Aptech Caswire (Extension) Ltd.

Structural Inspection Report

Observation-01: Lack of Design Report (Warehouse Building)

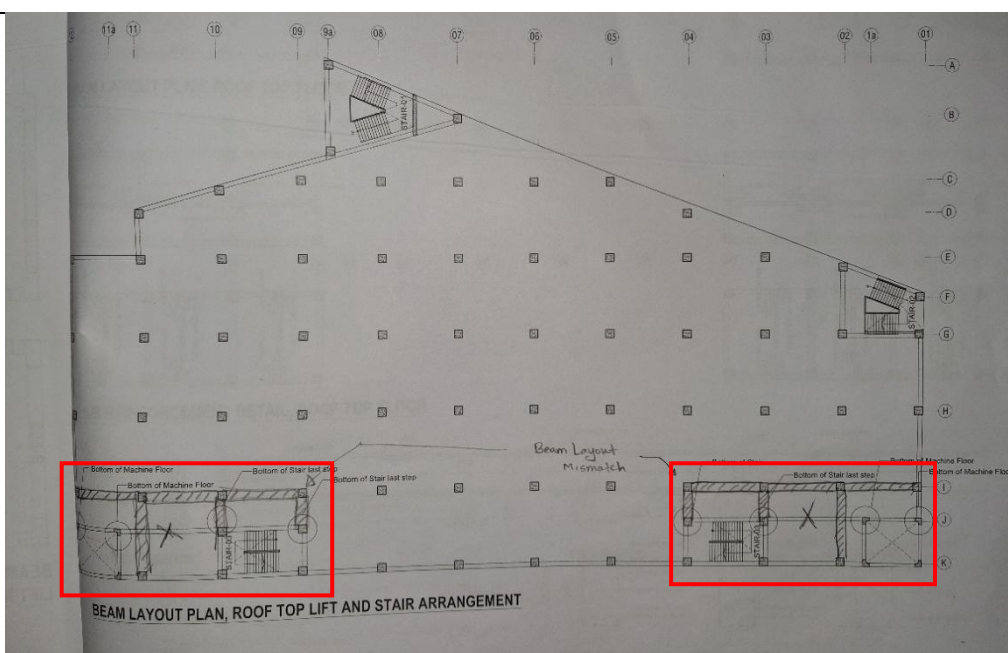
Description: At the time of inspection, the design report for this building was not available on site. Additionally, irregularity in stiffness observed in the building as ground to 4th floor is beam column frame and 5th floor is column-flat plate slab system.

Moreover, number of cylinder test report for column and beam-slab was found inadequate. Building engineer is required to verify the in-situ concrete strength by taking 100 mm diameter concrete cores (minimum 4 no's) from the lower tier columns and from beams.

Based on the in-situ material strength, the building engineer is required to prepare the Engineering Assessment (EA) in compliance with section 1.9.1.1 and section 1.9.1.2, part-6 of BNBC which includes vertical and horizontal irregularity checks.

Item No	Observation	Action Plan	Timeline
1.	Lack of Design Report (Warehouse Building)	The building engineer is required to prepare the design report as per 1.9.1 BNBC which includes vertical & horizontal irregularity checks and submit it to RSC for detailed review.	within 6 weeks

2.	Lack of Design Report (Warehouse Building)	Building engineer is required to verify the in-situ concrete strength by taking 100 mm diameter concrete cores (minimum 4 no's) from the lower tier columns and from beams.	within 6 weeks

Observation-05: Lack of Design Report (ACL Extension Building)

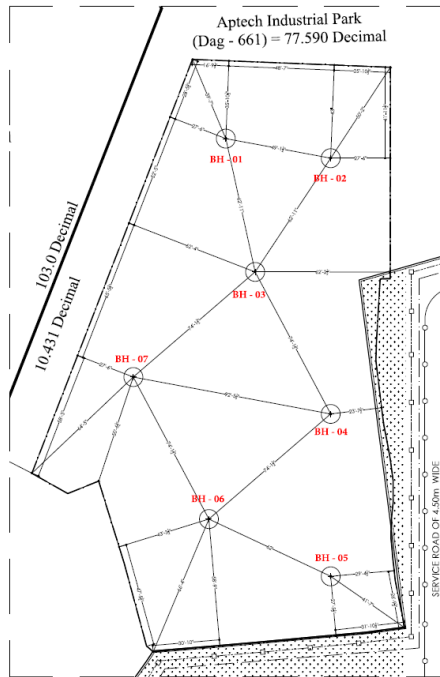
Description: At the time of inspection, the design report for this building was not available on site. As per BNBC, every building or structure designed shall have its design documents prepared following the provisions of Section 1.9.1. The design document shall include a design report and a set of structural drawings, which shall be prepared in compliance with section 1.9.1.1 and section 1.9.1.2 as per BNBC.

Moreover, number of cylinder test report for column and beam-slab was found inadequate. Building engineer is required to verify the in-situ concrete strength by taking 100 mm diameter concrete cores (minimum 4 no's) from the lower tier columns and from beams.

Based on the in-situ material strength, the building engineer is required to prepare the Engineering Assessment (EA) in compliance with section 1.9.1.1 and section 1.9.1.2, part-6 of BNBC.

7.	Lack of Design Report (ACL Extension Building)	The building engineer is required to prepare the design report as per 1.9.1 BNBC and submit it to RSC for detailed review.	within 6 weeks

8.	Lack of Design Report (ACL Extension Building)	Building engineer is required to verify the in-situ concrete strength by taking 100 mm diameter concrete cores (minimum 4 no's) from the lower tier columns and from beams.	within 6 weeks
